Request for Advice

Application No. **SSD-93020230**
Property Address **40-48 Redan Street, Mosman**

Extract from sun eye view diagram (12noon, mid-winter) with comments (Source: Drawing 6002, FJC Studio)

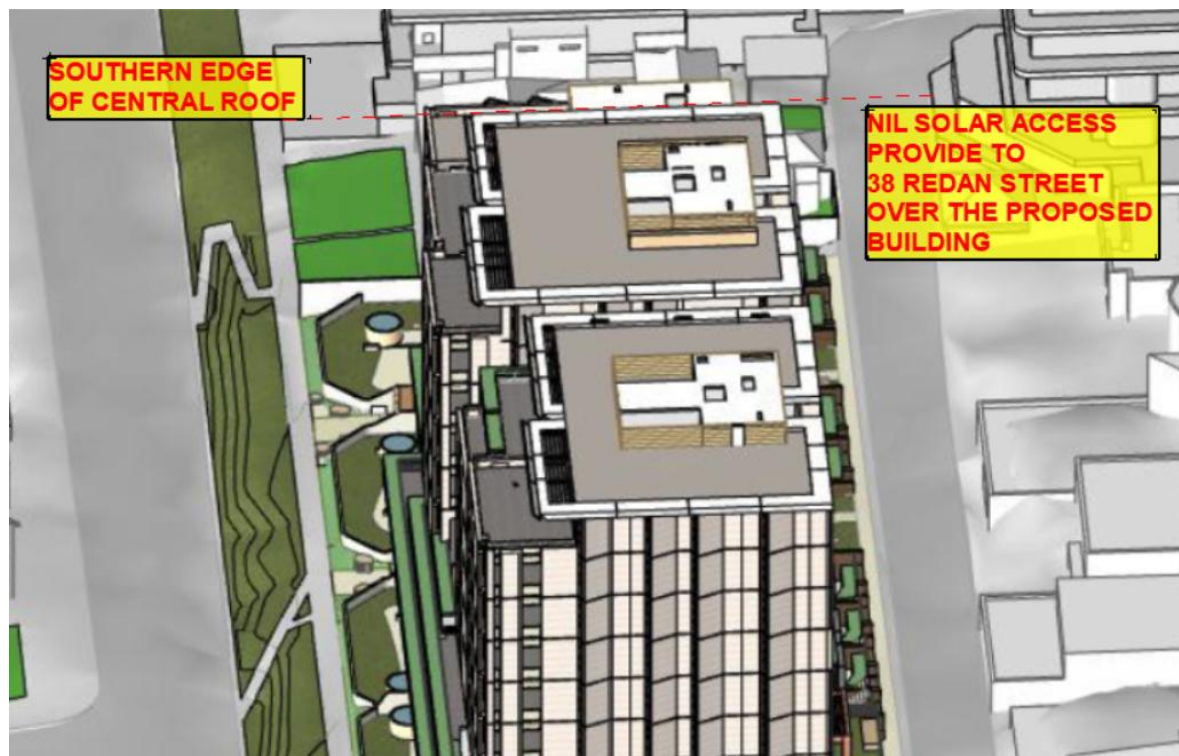
Solar access diagrams show that the central roof proposed on the subject site is currently set at a height that prevents any direct solar access to 38 Redan Street. The drawing extract below shows that when the sun is at its highest point in winter (12noon) no direct solar access will be provided over the top of the building.

Solar access to the neighbouring site is achieved in the morning and afternoon around the edges of the proposed building on the subject site, as shown in the drawing extract (on the following page).

As such the important factors in minimising the overshadowing of 38 Redan Street are the footprint of the proposed building and its proximity to the southern boundary. The stepping of the southern-most element has no solar access benefit for 38 Redan Street and its proximity to the southern boundary crowds the neighbouring heritage building. The removal of this form will improve the proposal's relationship with the neighbouring heritage building.

Extract from sun eye view diagram (9am, mid-winter) with comments (Source: Drawing 6002, FJC Studio)

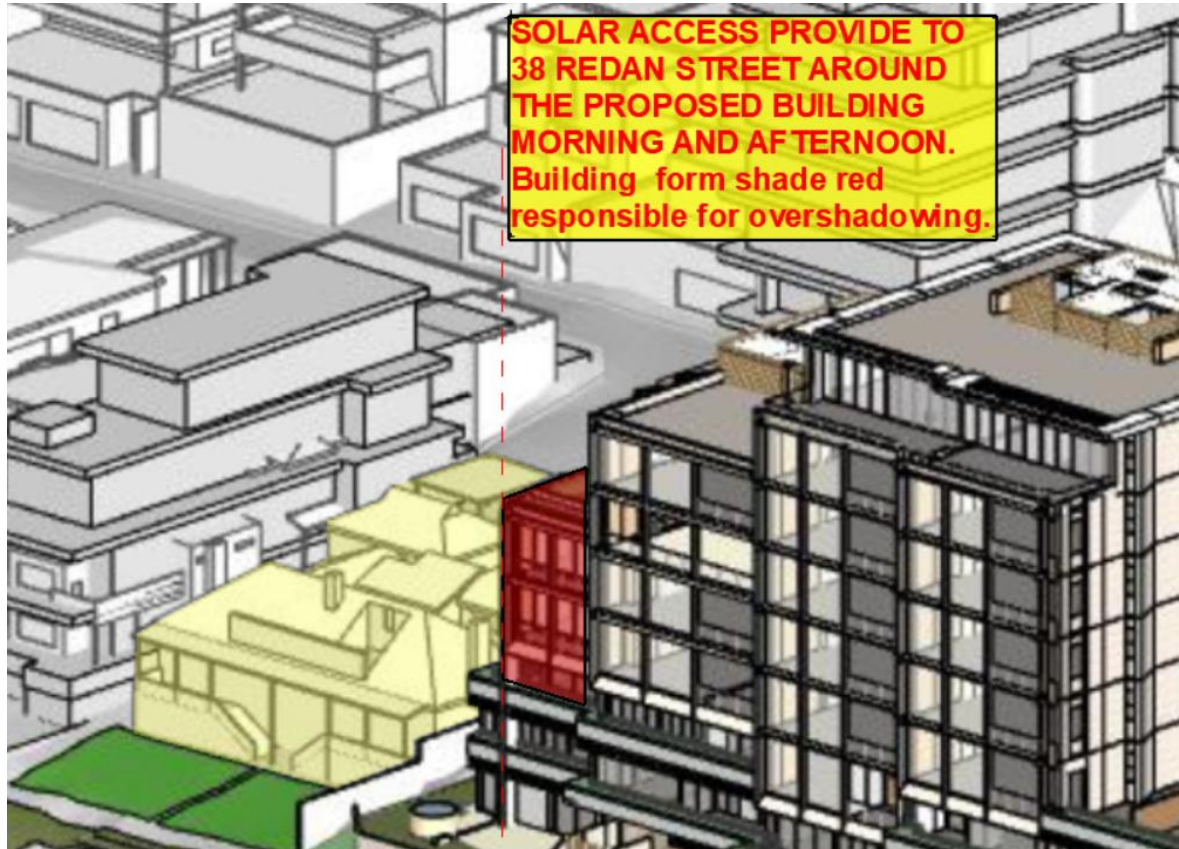
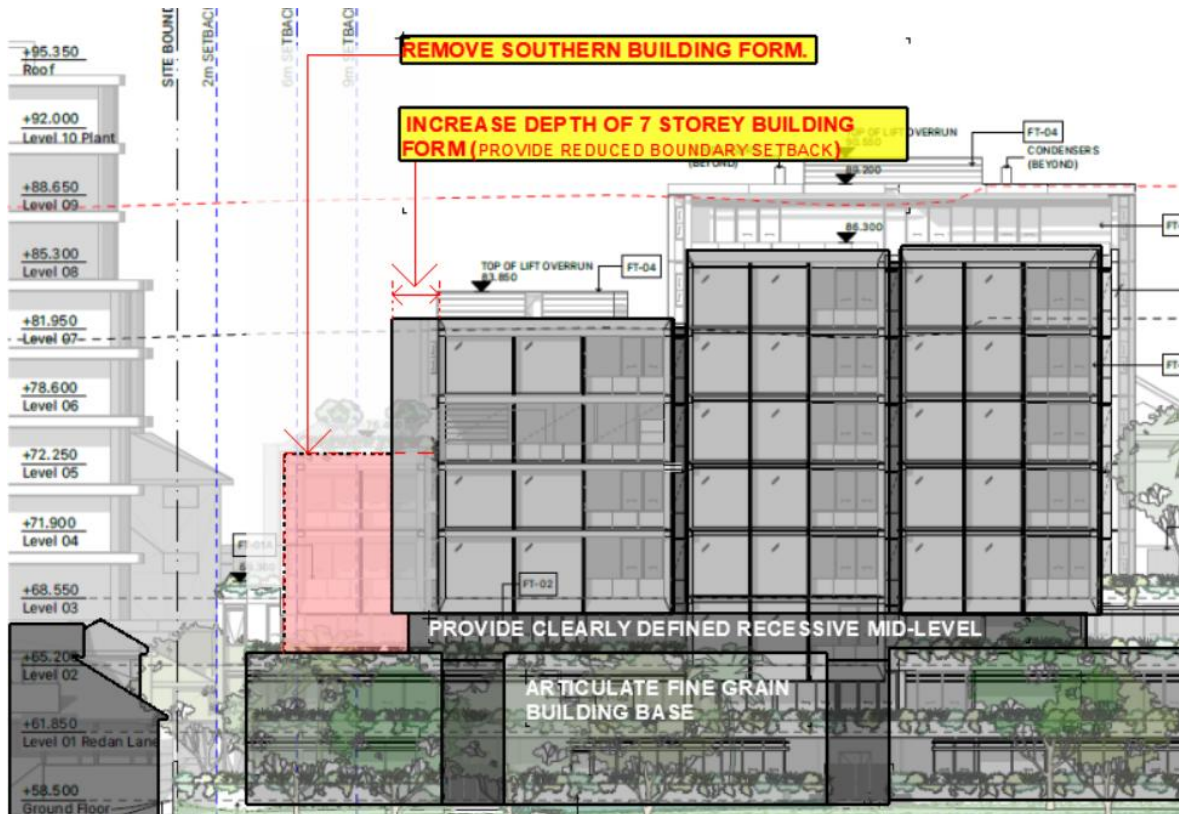
GFA could be shifted to compensate for amendments to the development design by adjusting the footprint of the seven-storey building form adjacent to the southern boundary, as outlined in the drawing extract (on the following page).

Extract from COS diagrams (Source: Drawing 6005, FJC Studio)

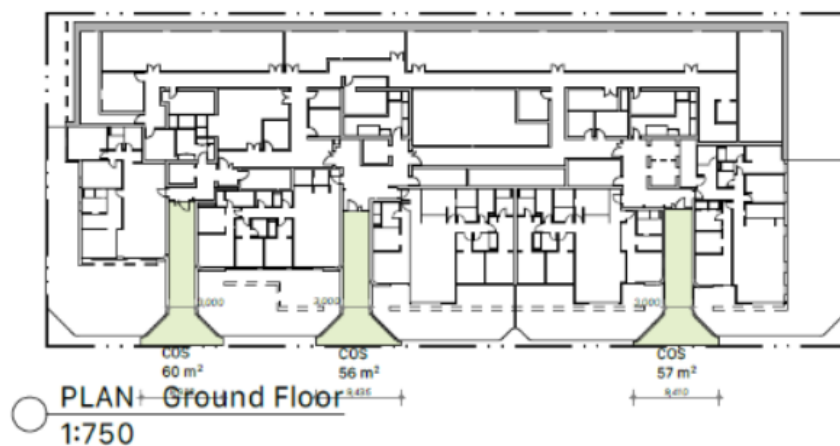
The primary area of COS is located at level 5 on the southern edge of the building. The COS roof terrace is only readily accessible to the southern unit block, which contains approximately 20% of units within the development. The remaining 80% of units are required to access the COS via a series of back of house corridors that pass through each of the ground floor lobbies, or access via the southern lift within the basement carpark. Clear and equitable access to the primary area of COS has not been provided to the majority of units.

Objective 3D-1 of the ADG requires communal open space to have a minimum area equal to 25% of the site, this equates to a requirement for 808sqm of COS on the subject site.

When these factors are taken into account (832.7sqm COS – 310sqm = 517sqm COS) insufficient COS has been provided to meet ADG design objectives. It is recommended that additional COS is provided in the northern portion of the site at ground level.

Extract from Level 5 plan with mark-up and suggested communal room (Source: Drawing 2107, FJC Studio)

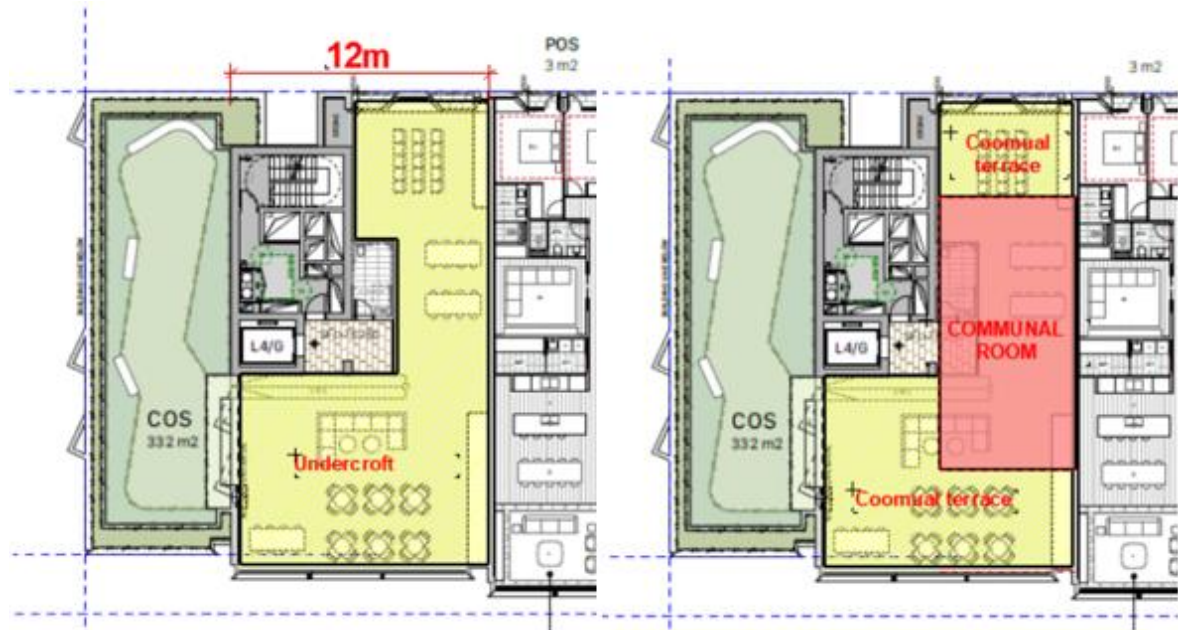
The proposed roof top COS predominantly consists of a 12m deep under-croft space that will be dependent upon artificial lighting 24 hours a day. It is suggested that this space be developed into a combination of communal room and well-proportioned terraces, as outlined in the diagram below.

Extract of floor plans with mark-up to highlight circulation issues
 (Source: Drawings 2102, 2105, and 2107, FJC Studio)

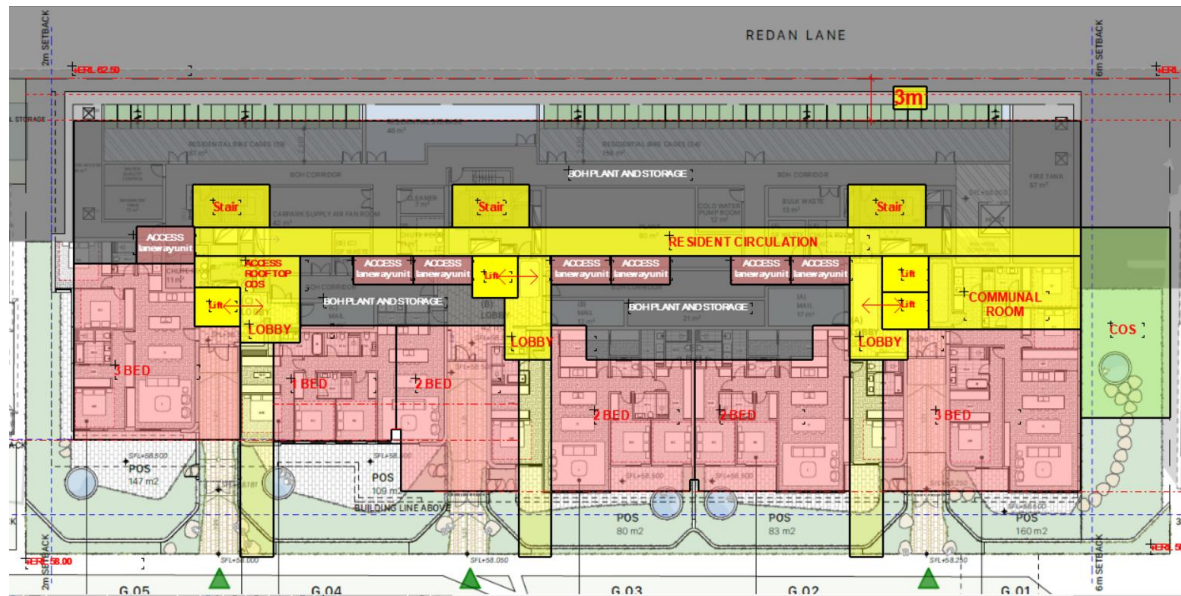
- The two-storey laneway units have no direct access to the carpark; Resident are required to exit the site to access their unit once they have parked their car.

- Residential lobbies are very tight, and lifts are obscured from view. The ground floor lobby area to the southern building is particularly tight and contorted, as shown in the ground floor drawing extract below. With a narrow entry point from the street that also contains the front door to a residential unit and a lift that is obscured from view. The northern ground floor lobby will also provide the point of access to primary area of rooftop COS.

- The northern ground floor unit has two front doors located side by side. One is accessed via the lift the other via the lobby. Which door will resident answer when there is a knock at the door?

- ADG object 4F-1 states: *Daylight and natural ventilation should be provided to all common circulation spaces that are above ground.*
- Upper-level lobbies are tightly proportioned and have no access to natural light, as shown in the levels 3 and 5 drawing extracts below. ADG design objectives are not achieved.
- Numerous lifts discharge directly into residential units. In some instances, no security door is provided between lift and unit, as shown in the level 3 drawing extracts below. This will compromise resident privacy when the lift is being shared by residents and create a potential security risk.

Further development is required to provide a more rational circulation strategy, a diagram outlining a potential strategy for ground floor circulation is shown below. Entrances are aligned with lifts, well-proportioned lobbies are provided, an access corridor independent of lobbies connects the northern COS with access to the rooftop COS and access from the basement is provided to all two storey laneway apartments.

Extract from Level 4 plan highlighting habitable rooms with no windows (Source: Drawing 2106, FJC Studio)

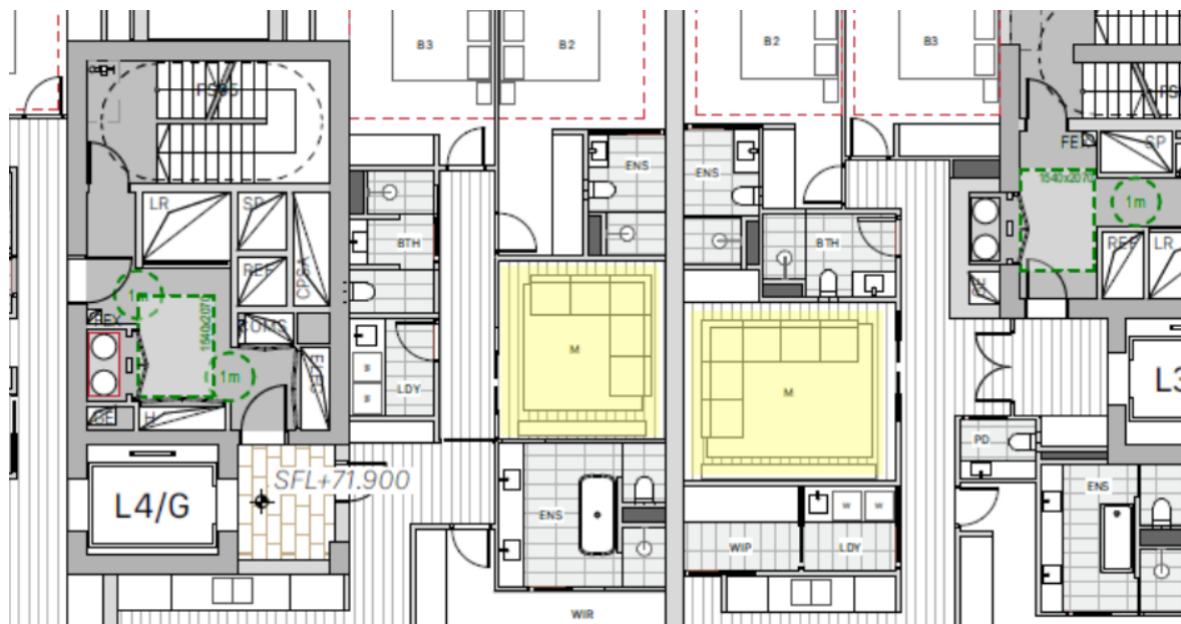
Units 3.04, 3.05, 4.04, 4.05, 5.04, 604 and 605 contain habitable rooms that have no access to an external window. It is a concern that these rooms will be dependent upon artificial lighting 24 hours a day.

Extract from deep soil zone area diagrams documenting areas included in 3m x 3m deep soil zones (Source: Drawing 6006, FJC Studio)

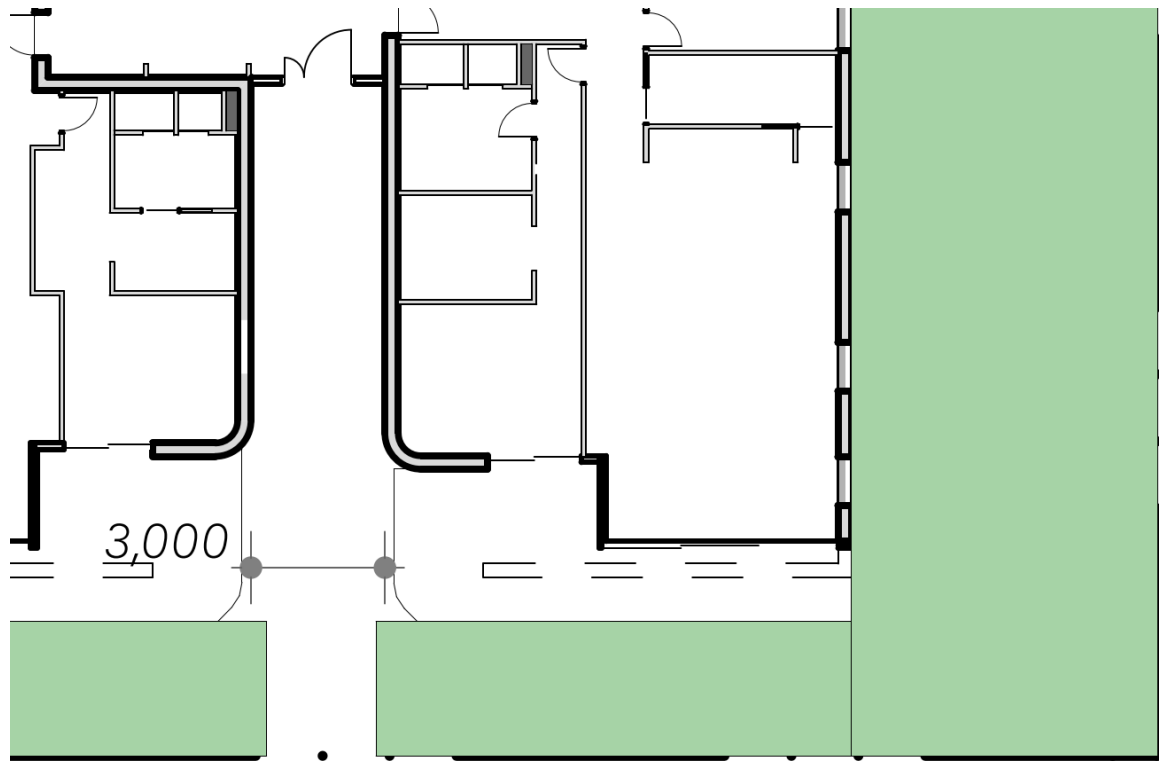
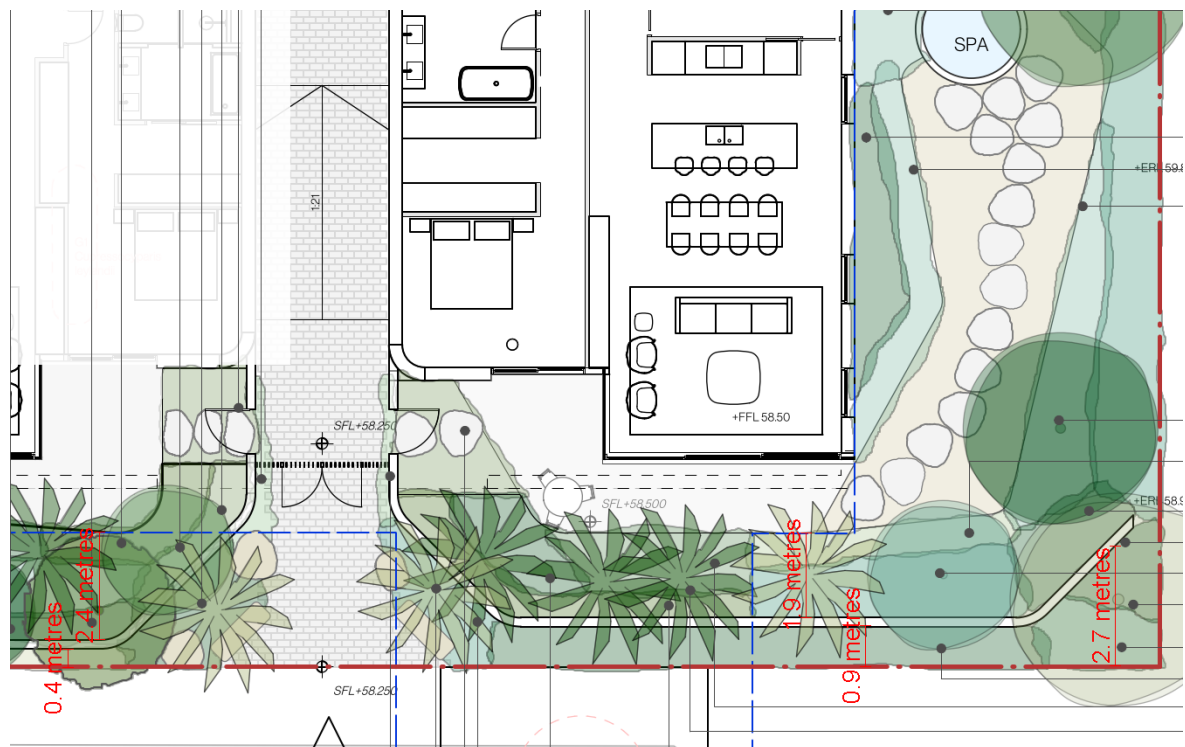
The application documents include discrepancies with regard to proposed deep soil zone area of the development with the architectural deep soil zone area diagrams documenting 533.2sqm or 16.49% and the EIS stating 495.3sqm or 15.3%.

The applicant's calculation of deep soil zone fails to comply with the above definition as it includes many areas that do not meet the minimum 3m x 3m (9sqm area) requirement. Examples include, but are not limited to the following:

- The front garden areas of the eastern apartments include retaining walls due to changes in levels in response to site topography. These areas have been included in the 3m x 3m deep soil calculations which is incorrect.
- The southern setback area on Level 1 (near the western Redan Lane frontage) has been included in the deep soil zone calculations, however the setback from the southern boundary is only 2m.
- Structures such as spas have been incorrectly included in the deep soil calculations.

The exclusion of structures and areas which do not meet the 3m x 3m deep soil zone requirements (from deep soil zone calculations), results in a deep soil zone subtraction of 287.9sqm from the figures presented in the application documents in accordance with Council's calculations. In this respect, the EIS figure of deep soil (495.3sqm or 15.3%) would be reduced to 207.4sqm or 6.4% which is well below the 15% requirement of the Tree Canopy Guide for LMR Housing and below the Min. 7% deep soil zone requirement of the Apartment Design Guide (ADG).

Given the sensitive location of the site being within the Scenic Protection Area there is strong merit in applying the enhanced provisions under Table 7. When the Table 7 provisions are applied, the proposal has a shortfall of 277.55sqm from the 15% deep soil requirement (484.95sqm).

View of the Redan Lane frontage (Source: Architectural Design Report, FJC Studio)

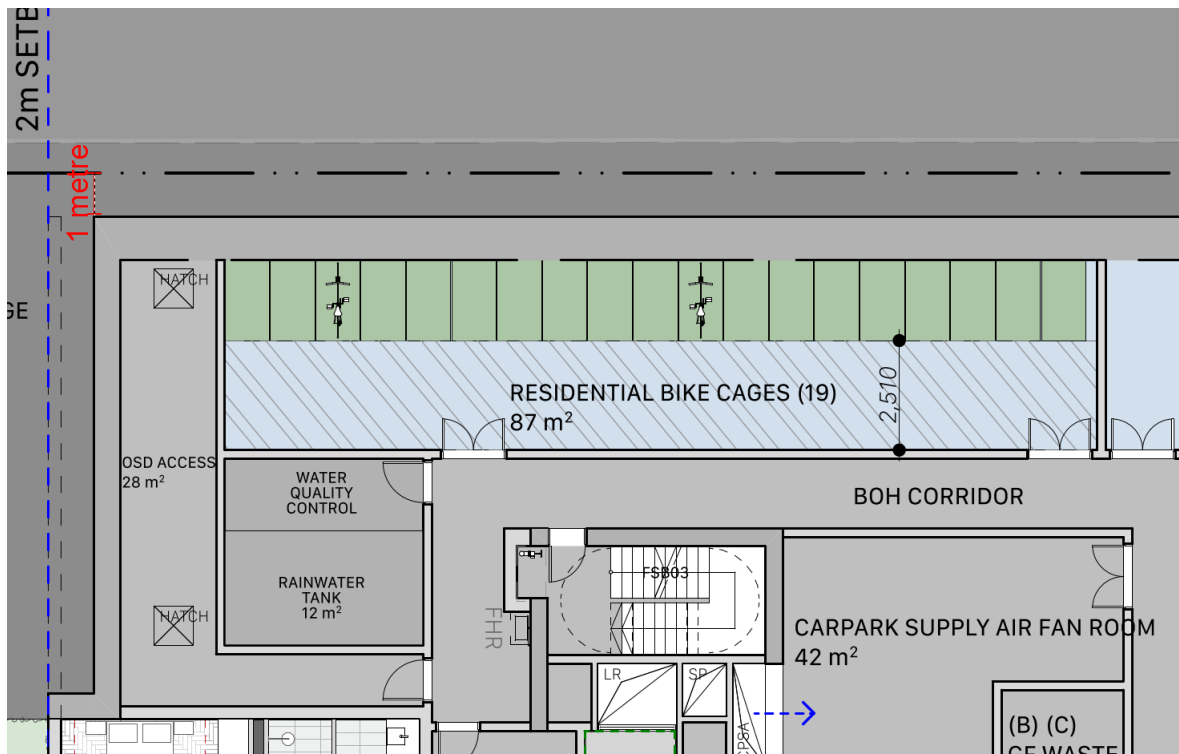
While Council acknowledges that the public domain improvements incorporated have been done so with good intentions, the proposal’s delivery of green amenity to the public domain and its sustainability is in question given the lack of deep soil depth adjacent to the site’s eastern and western boundaries. In particular, the setback from the Redan Lane property boundary is only 1m over three levels of basement including two levels of basement car parking, and one level of basement services and bicycle parking. This leaves very little deep soil to sustain planting that positively contributes to the streetscape and public domain
